WATTS BAR NUCLEAR PLANT (WBN) UNIT 1 - RESPONSE TO REQUEST FOR  
ADDITIONAL INFORMATION REGARDING REQUEST FOR LICENSE AMENDMENT TO  
TECHNICAL SPECIFICATIONS - SPENT FUEL POOL STORAGE CAPACITY  
INCREASE (TAC NO. M96930)

WATTS BAR NUCLEAR PLANT (WBN) UNIT 1  
REQUEST FOR ADDITIONAL INFORMATION  
SPENT FUEL POOL STORAGE CAPACITY

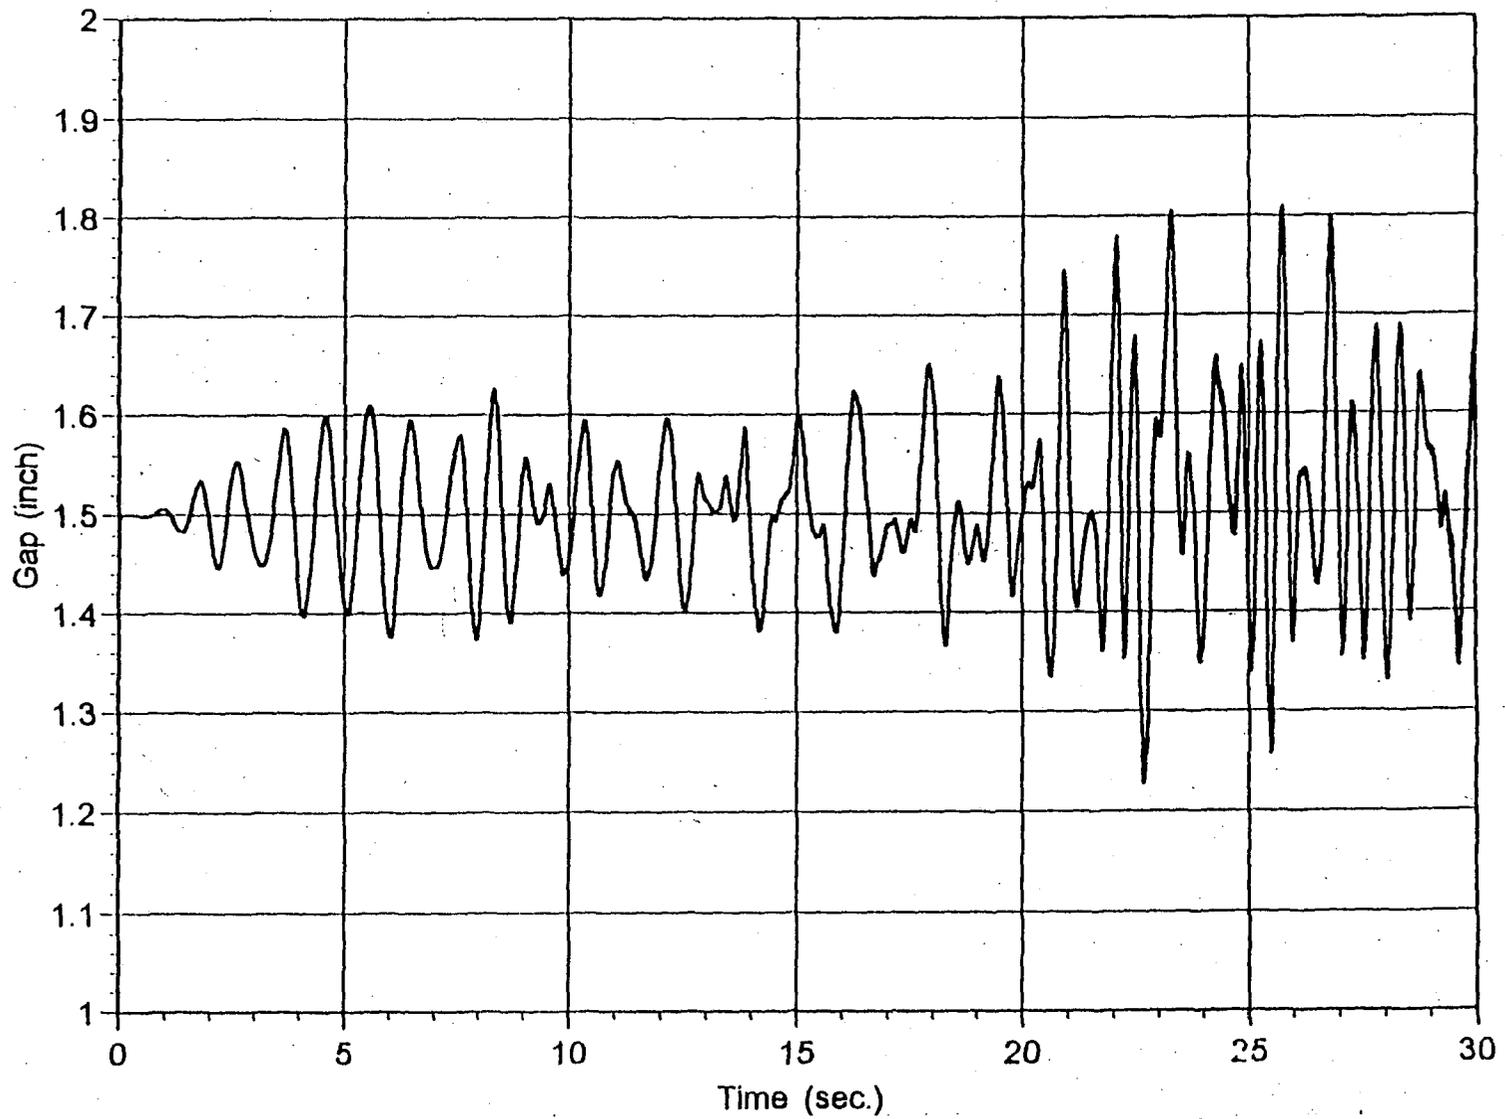
Provide the locations of the leak chase systems with respect to the locations of the racks and pedestals.

Figure 8.1 shows the layout of the racks and the leak chase system. The leak chase system in the floor of the spent fuel pool consists of leak channels around the periphery of the floor (see Figure 8.2, Section A-A), one east-west leak channel and eight north-south leak channels (see Figure 8.2, Sections B-B and C-C). The leak channel locations were considered when the rack layout was developed. However, it was not possible to avoid the leak channels entirely. Therefore, the bearing pads have been designed to ensure that the load from the rack pedestal is bridged across the leak channels and the concrete allowable stresses are not exceeded. Also, the rack layout does not cause a support pedestal to be located over the existing pits in the floor which were used for the existing rack supports (see Figure 8.3, Detail A).

Figure 2.1

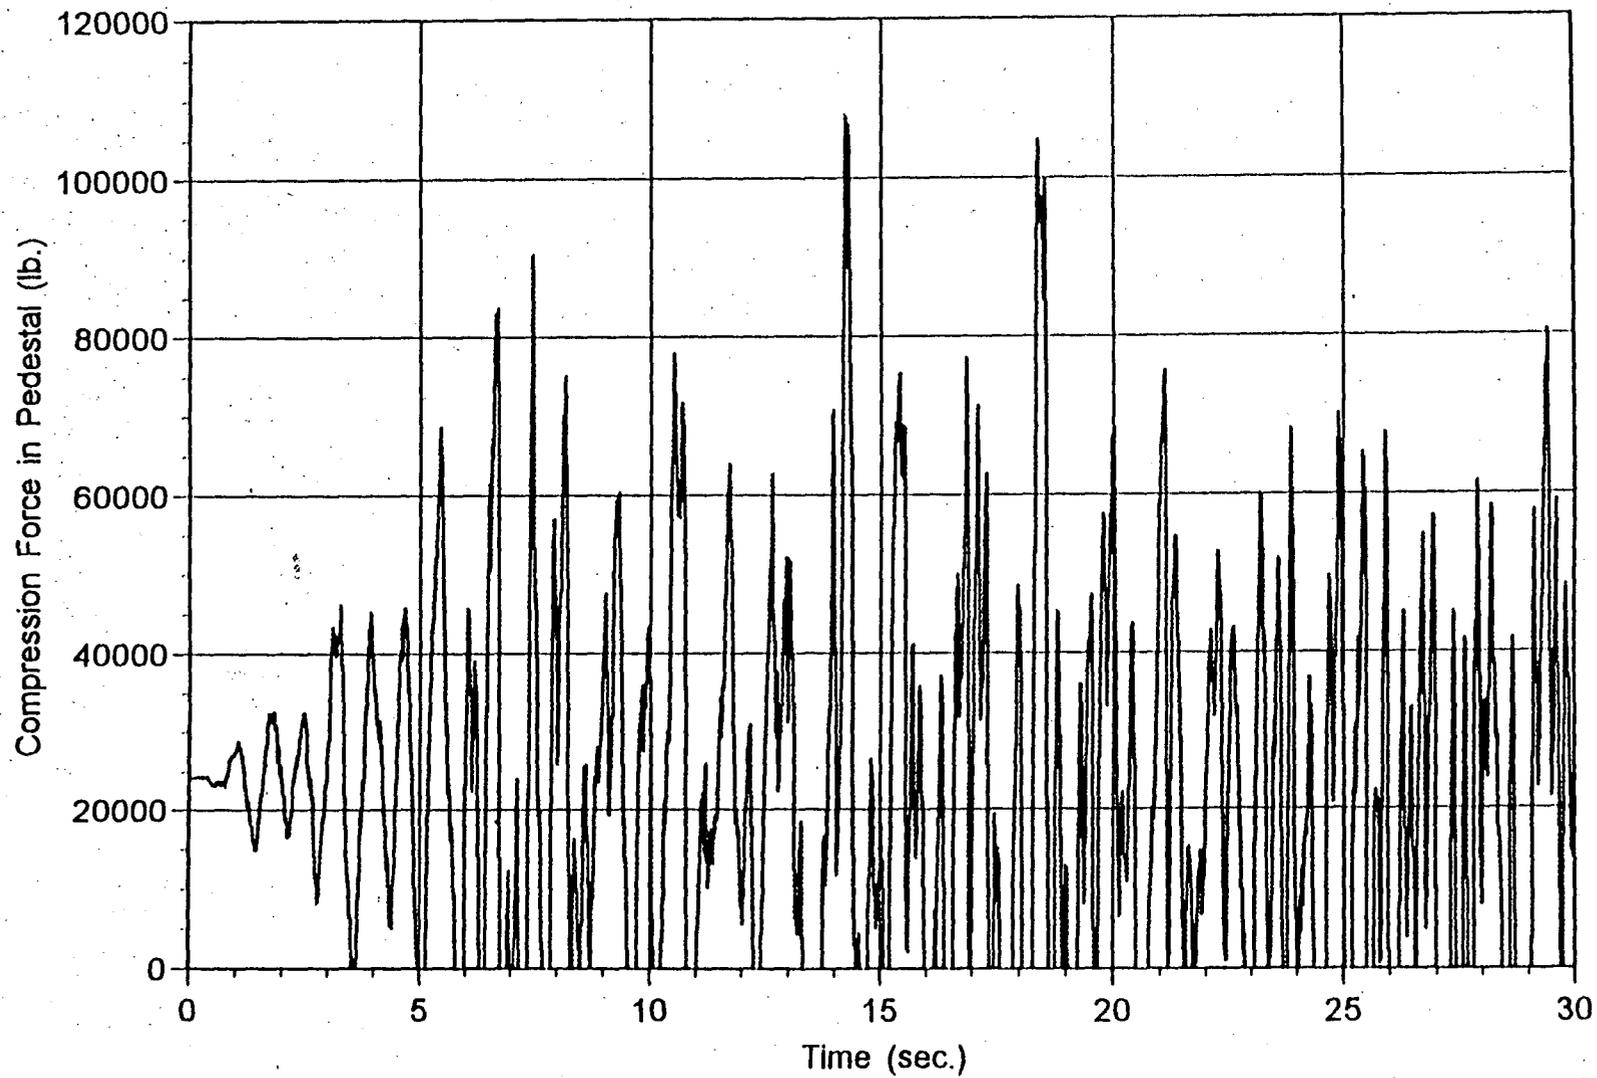
A comprehensive analysis of the results were not provided in the submittal (Reference 1) for staff review. Provide a summary of the analysis results (i.e., stresses, displacements, hydrodynamic pressure distribution, locations of the maximum responses, etc.) in a tabular form for the single- and multi-rack analyses.

The tables shown below provide the requested information. Figures 2.1 and 2.2 give representative gap and pedestal loads as a function of time.

Figure 4.1  
Concrete Stress-Strain Curves

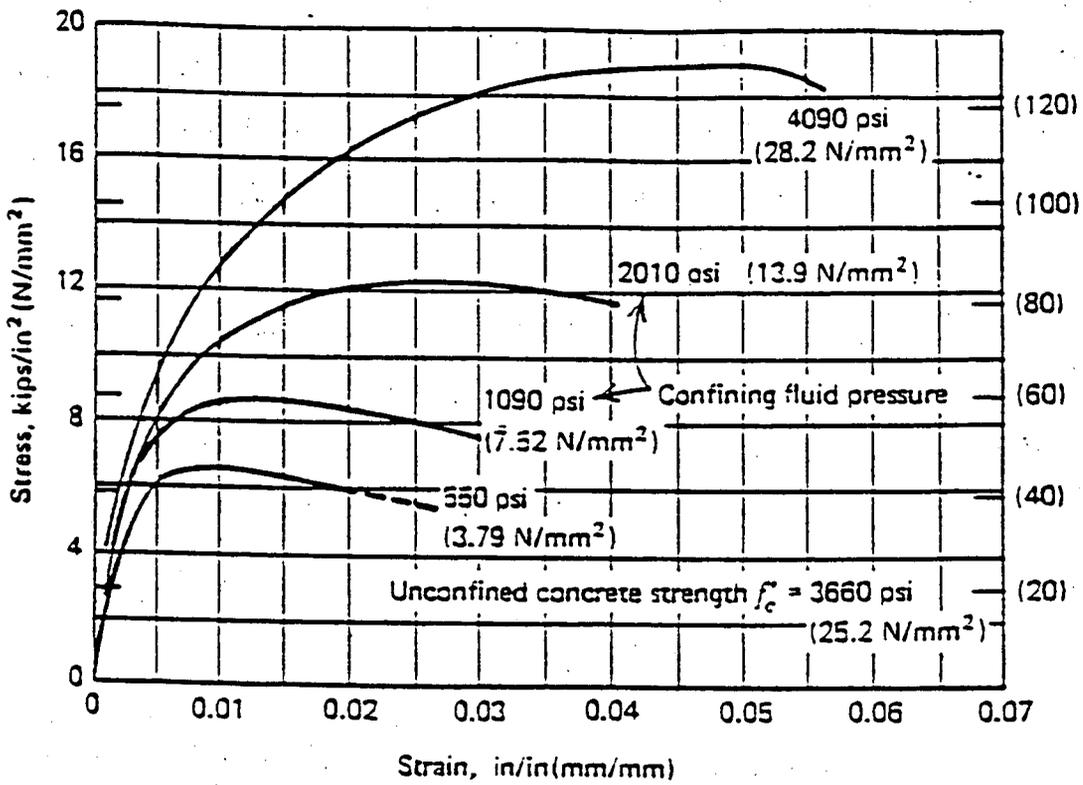
- a) analytical approaches or methodologies used,
- b) loading conditions,
- c) failure (tear and rupture) criteria
- d) material properties used including concrete bearing strength and the friction between the pedestal and liner, and
- e) complete summary of the analytical results in a tabular form.

Because the superior stratum of the concrete slab is laterally confined and simultaneously compressed from the interior of the pool by water pressure, it exhibits a tri-axial compressive stress behavior, which reduces the tendency for internal cracking. The stress-strain curve of various types of concrete subjected to tri-axial compression tests is depicted in Figure 4.1. For conservative reasons, in the absence of laboratory tests confirming a real stress-strain relationship of the pool slab concrete, the values representing the unconfined full capacity of concrete are used.

Figure 9.1

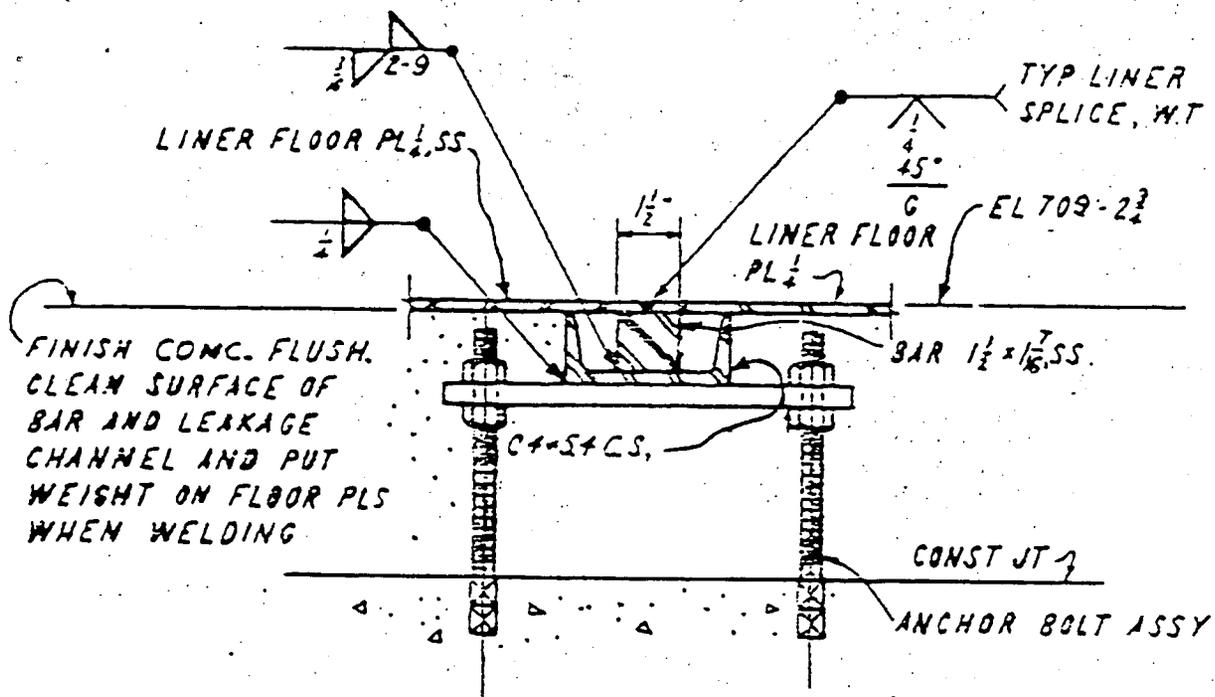
Describe how the liner plates are attached to the channels embedded in the concrete slab.

Figure 9.1 provides an excerpt from the TVA construction drawing which shows the detail of the connection of the liner plates at the leak channel.
